DRB Project Number: 2022-006935
10900, 10901, 10915 Juan Tabo Pl.

SUBJECT: Sketch Plat

Development Facilitation Team (DFT) – Review Comments

DRB Project Number: 2022-006935 Hearing Date: 06-21-2023
Project: Lot 1A – 14A, Juan Tabo Business Park Agenda Item No: 6

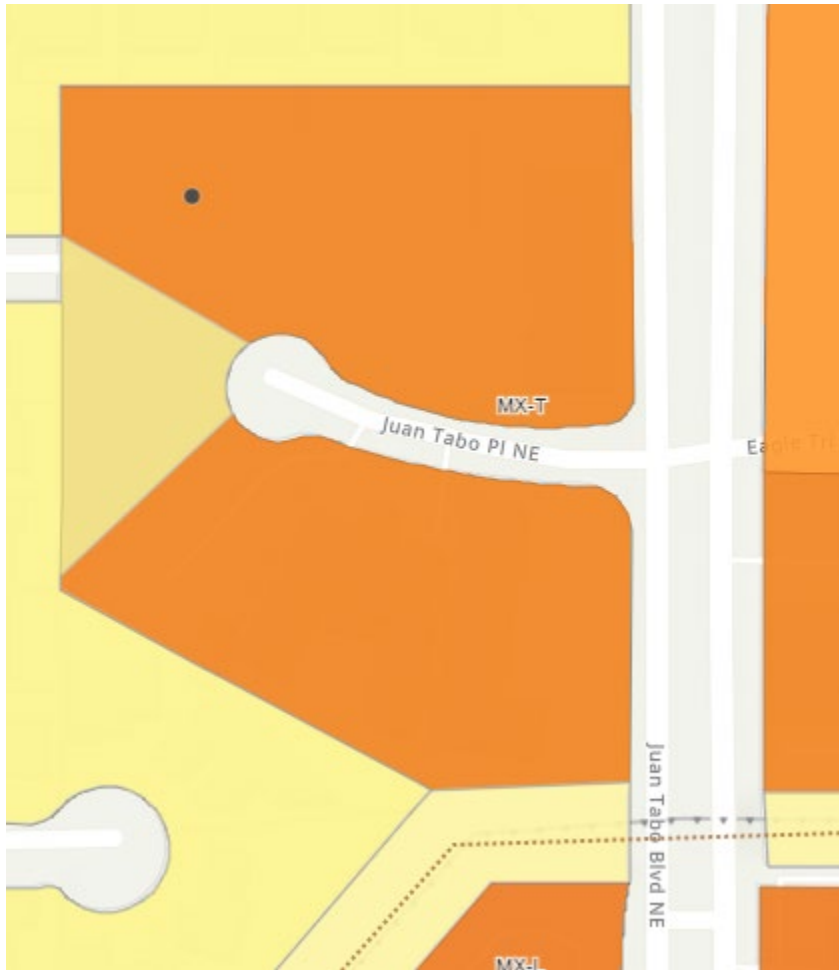
- Additionally, please note section **5-6-E-5. Area of Change Next to Area of Consistency** (Table 5-6-5). (Yellow = Area of Consistency, Orange=Area of Change).
-See illustration below-
